Town of Reading

Preliminary Subdivision Plan DECISION of APPROVAL

45 Beacon Street

Major Modification to a Definitive Subdivision Plan DECISION of APPROVAL

CONCEPT PLAN
ASSESSOR'S MAP 27, LOT 411
45 BEACON STREET
READING, MASSACHUSETTS

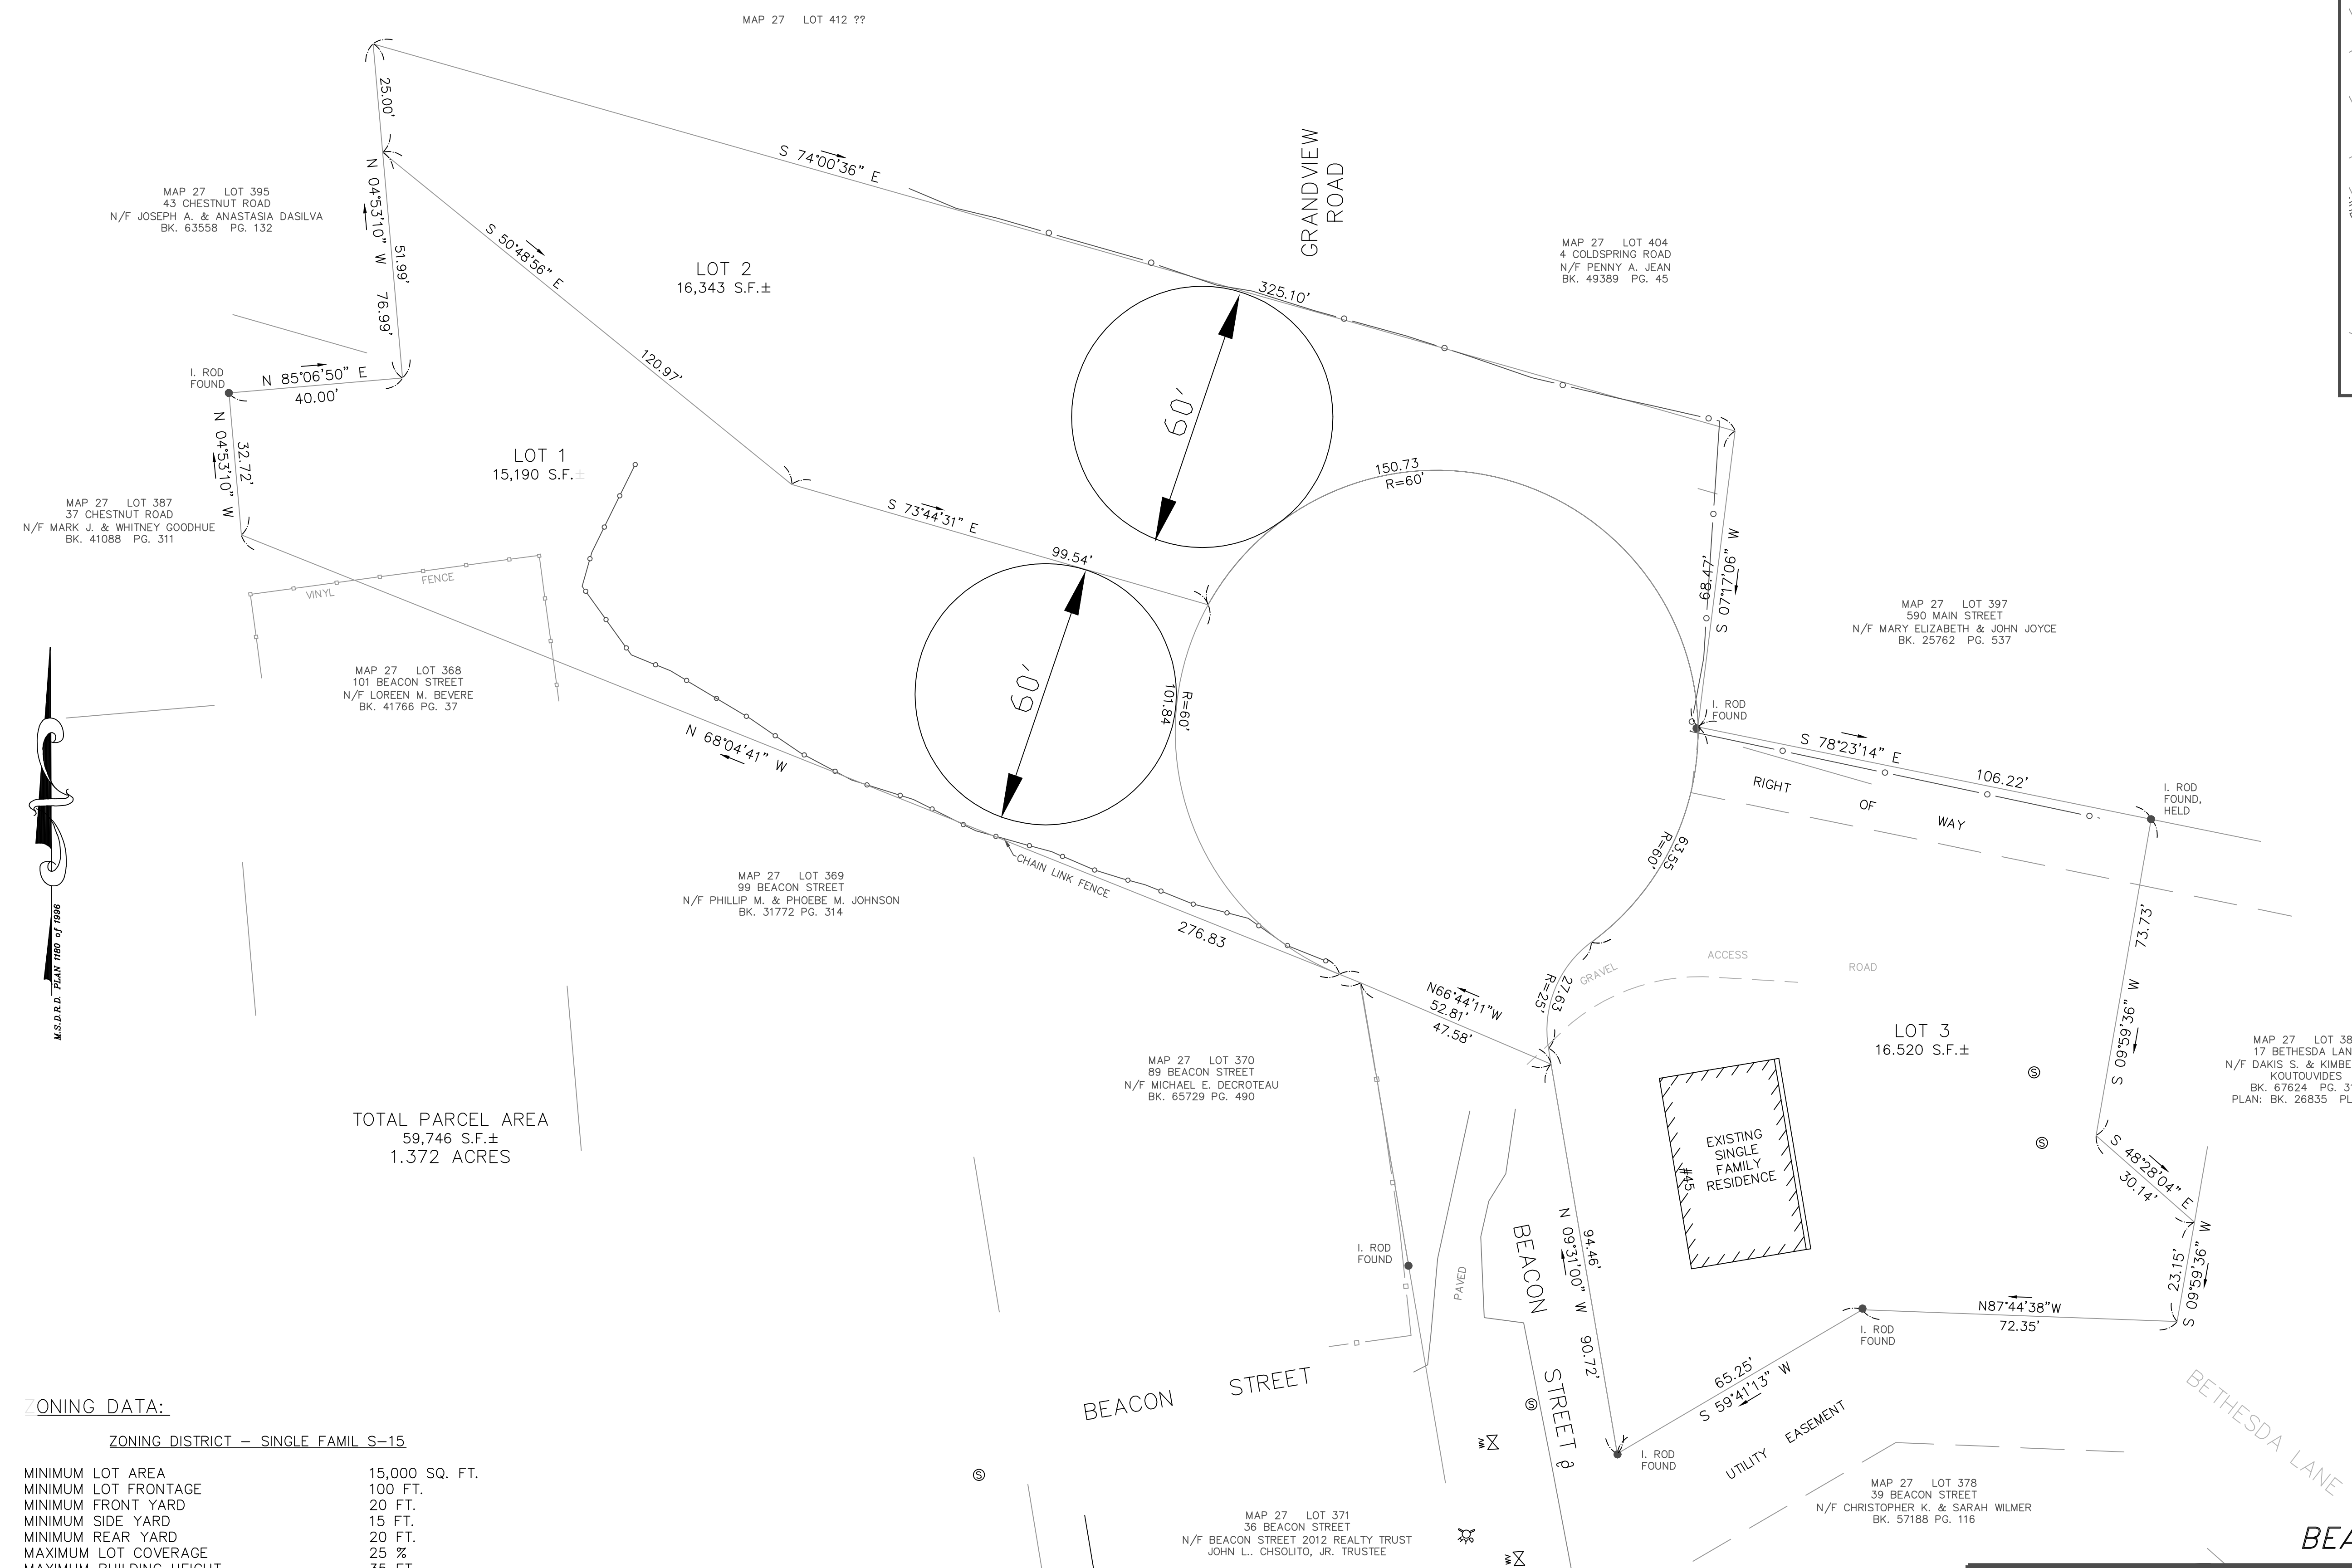
Item1. I have shown on the attached supplemental Sheet 1 an area where the applicant could widen the right of way to 60 feet. Such a widening of the right of way would require a variance from the frontage setback for 45 Beacon street and would provide the only 60 foot width in the entire street. Does not seem to be a reasonable requirement in an established neighborhood.

The area highlighted by the hatch in the plan is the only area in which the applicant could expand the Right of Way to 60 feet. In doing so it would require a zoning variance for a front yard setback for the existing house.

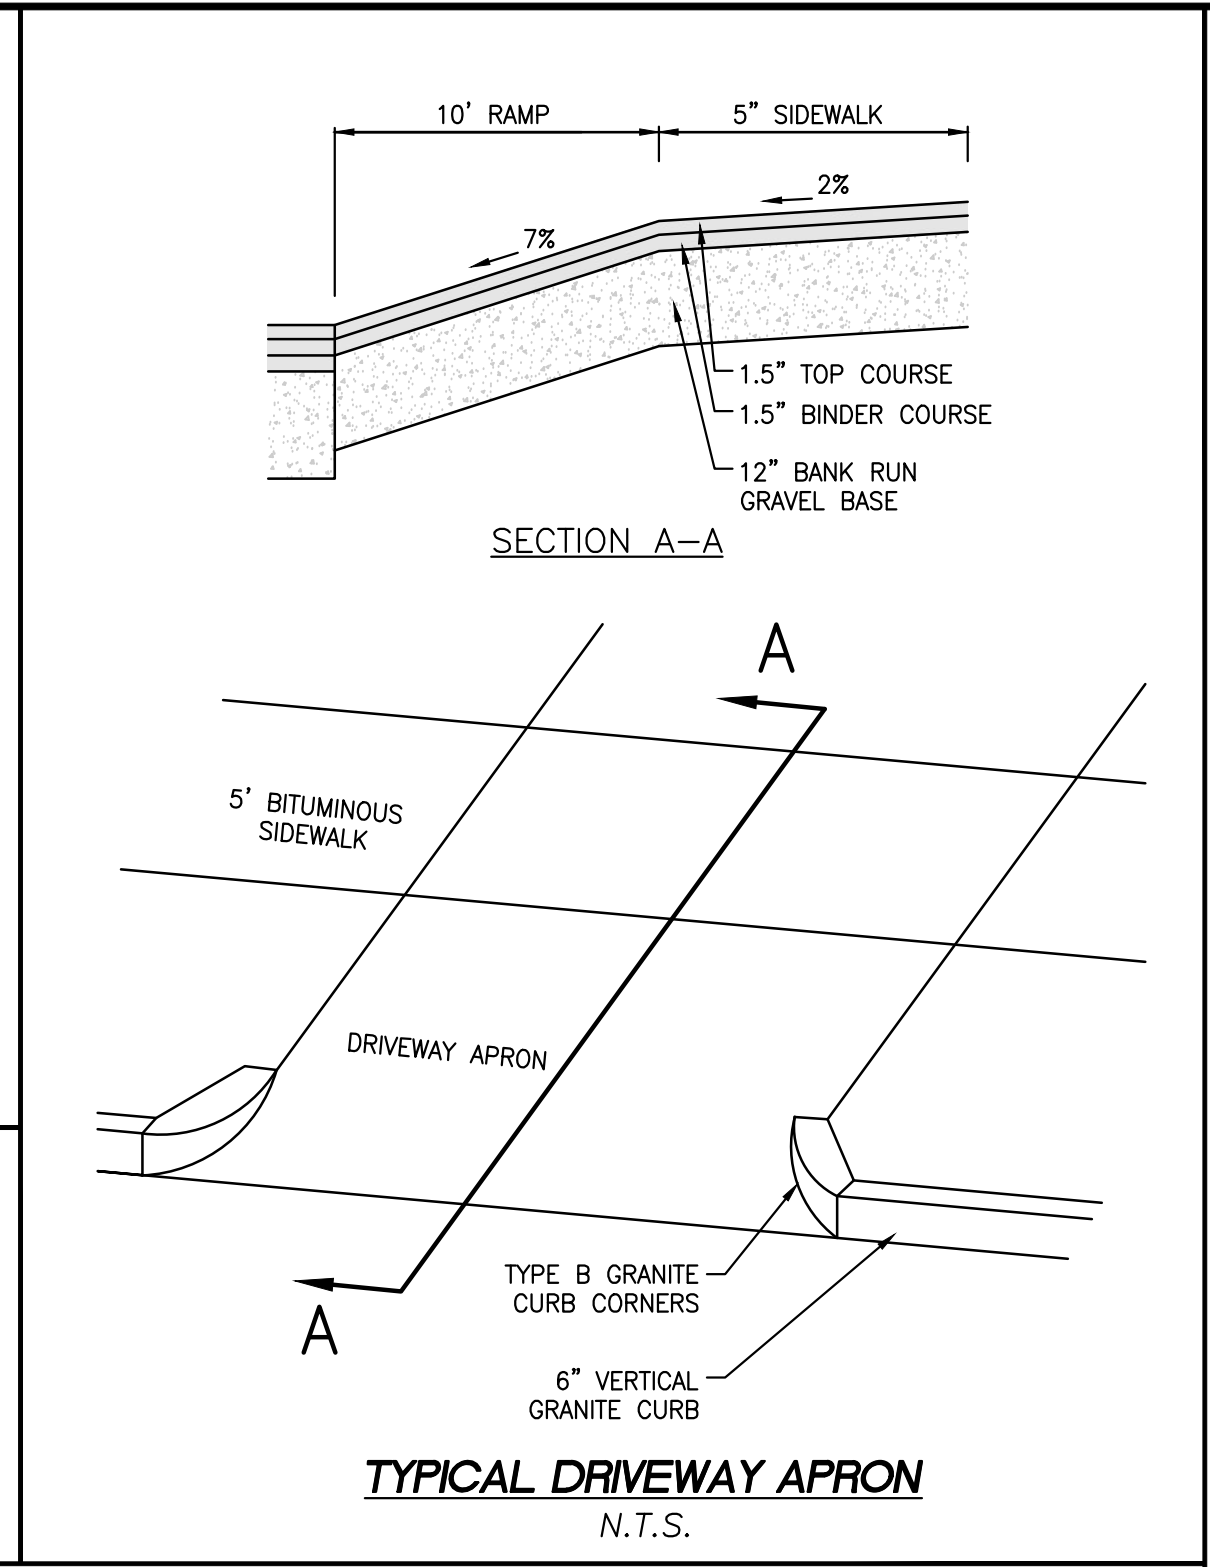
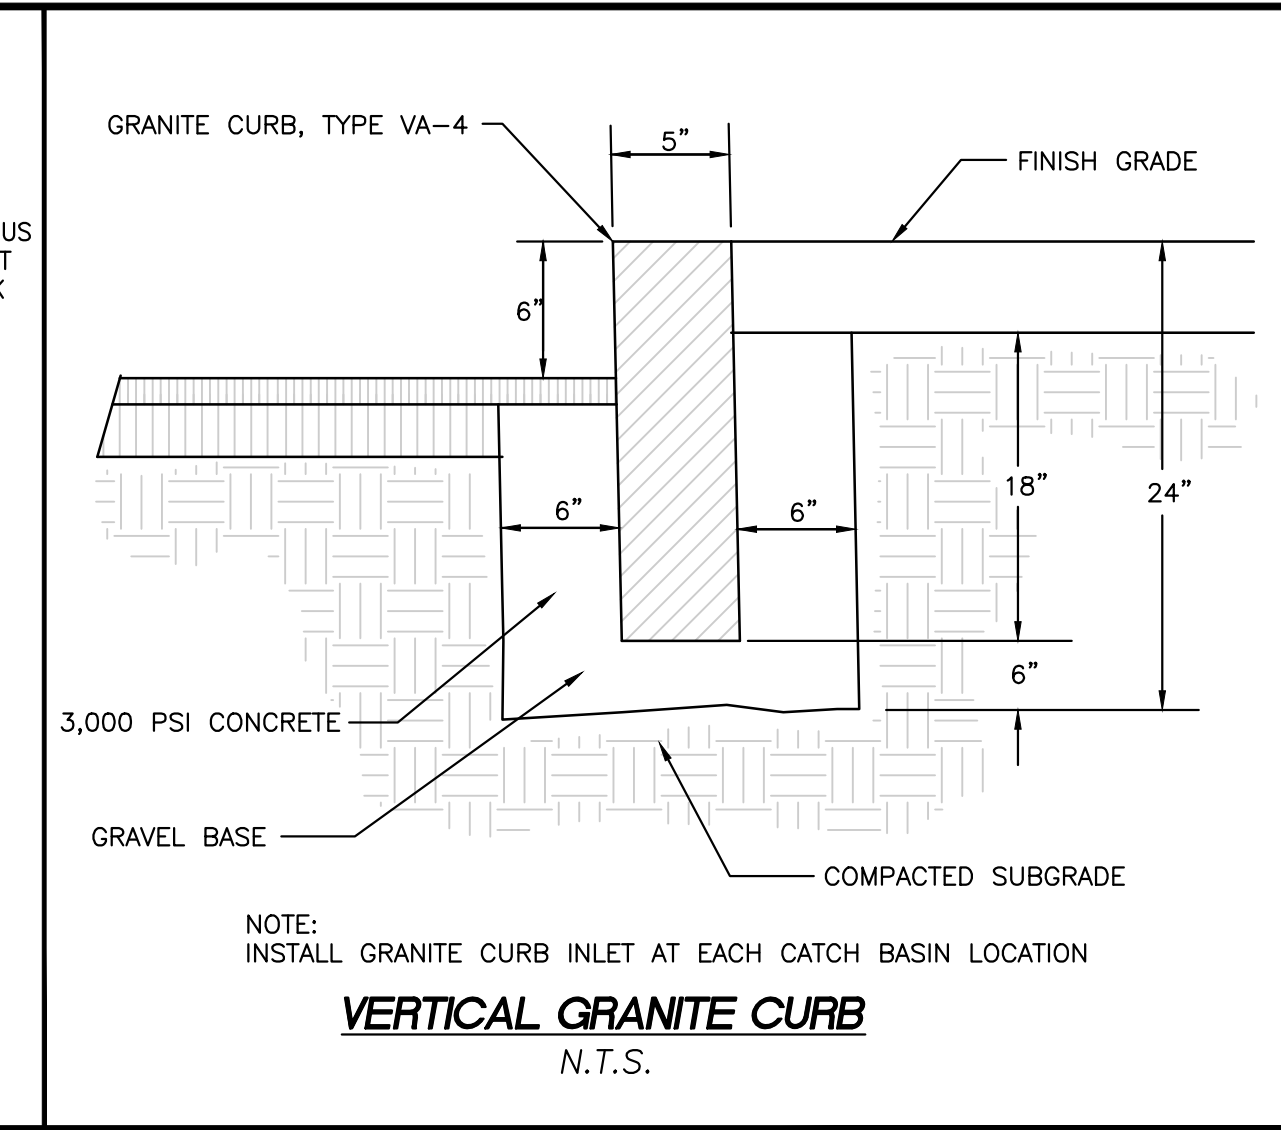
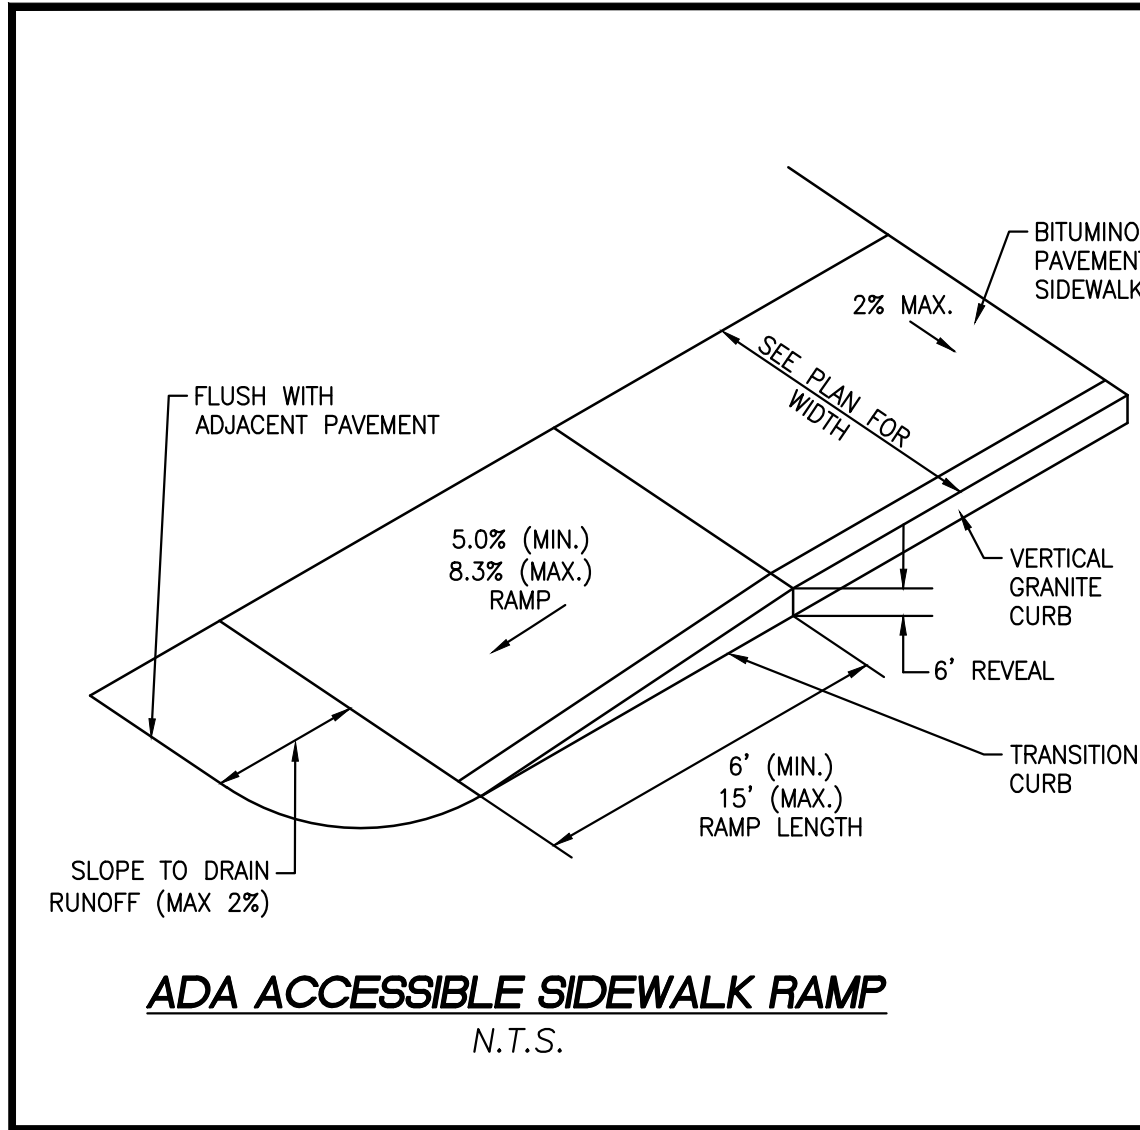
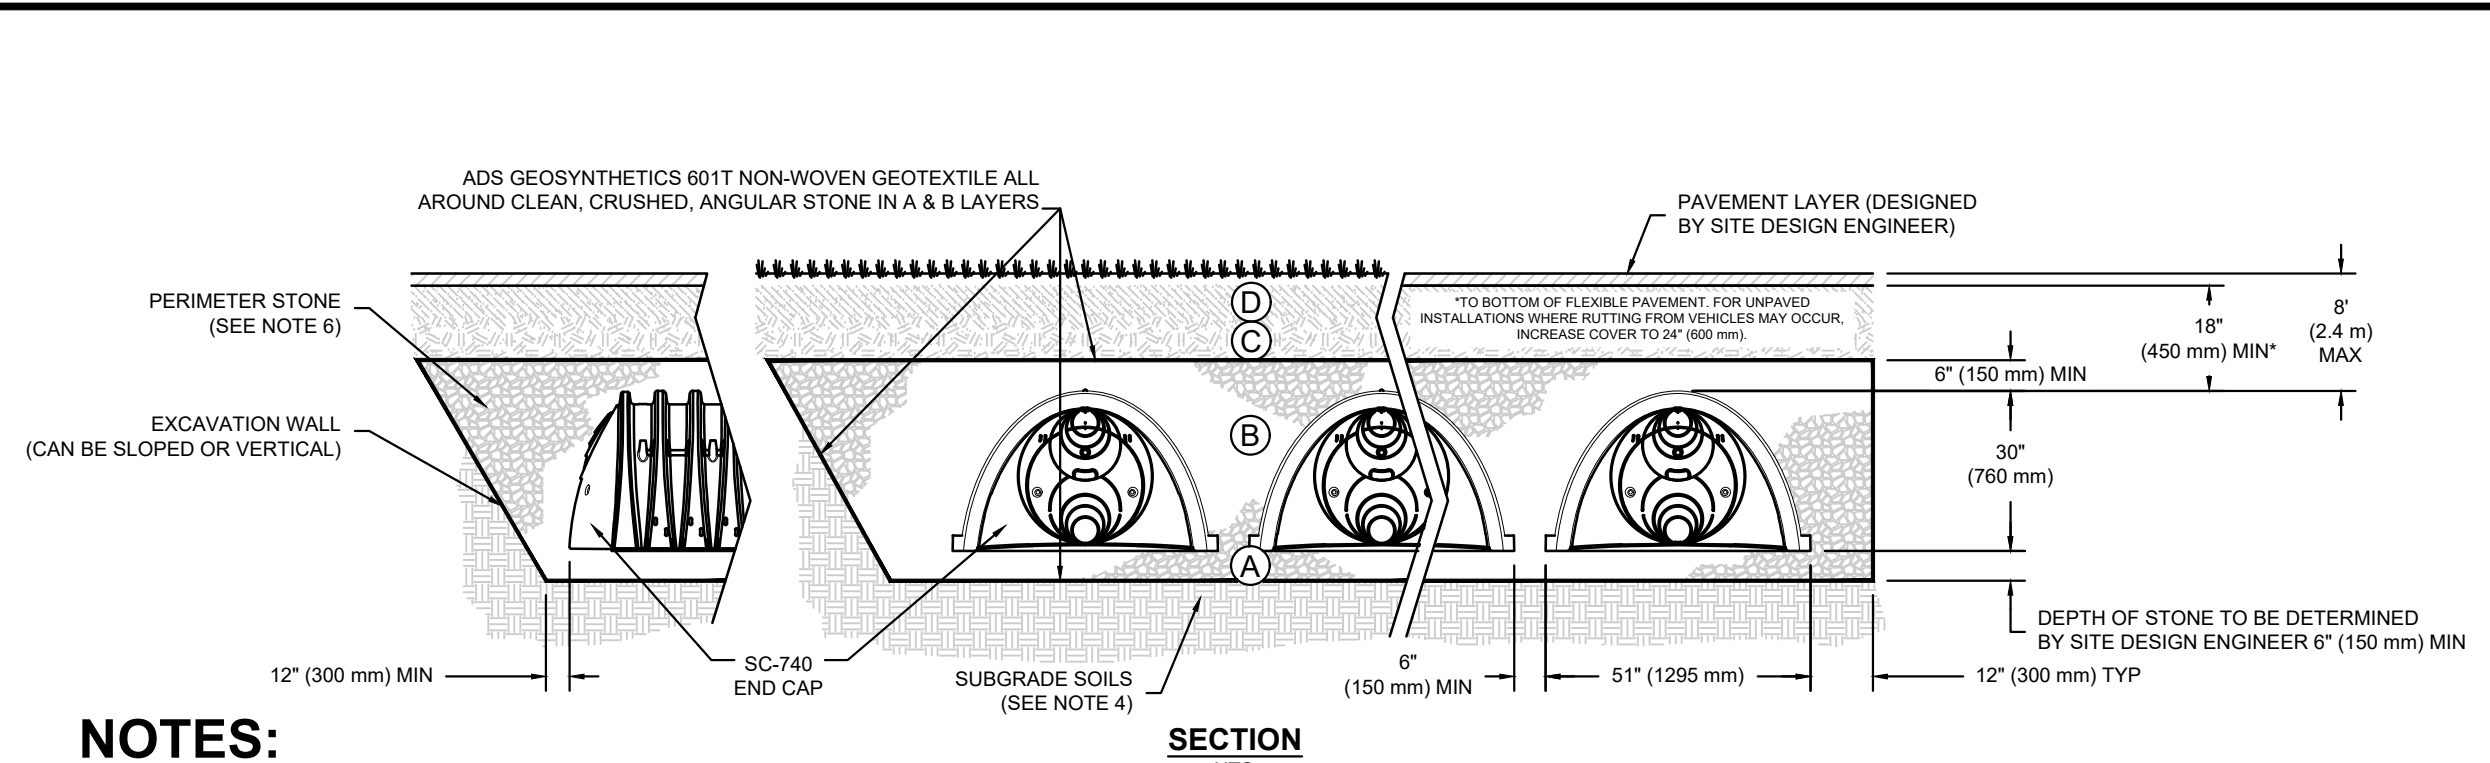
- There are many instances of utilities crossing, we are particularly concerned with the crossing of water and sewer. Crossings should be limited, and invert elevations of the services may be requested to ensure proper separation.
FE Response: We limited crossings of utilities but it is inevitable that crossings will occur. There is a “Water Main Crossing” detail on sheet C-6.

- Inverts of the existing sewer manhole should be provided, as well as a detail for the force main connection.
FE Response: Invert of the existing sewer manhole was provided by the surveyor and is INV=112.4. Details associated with the force main are on sheet C-6.
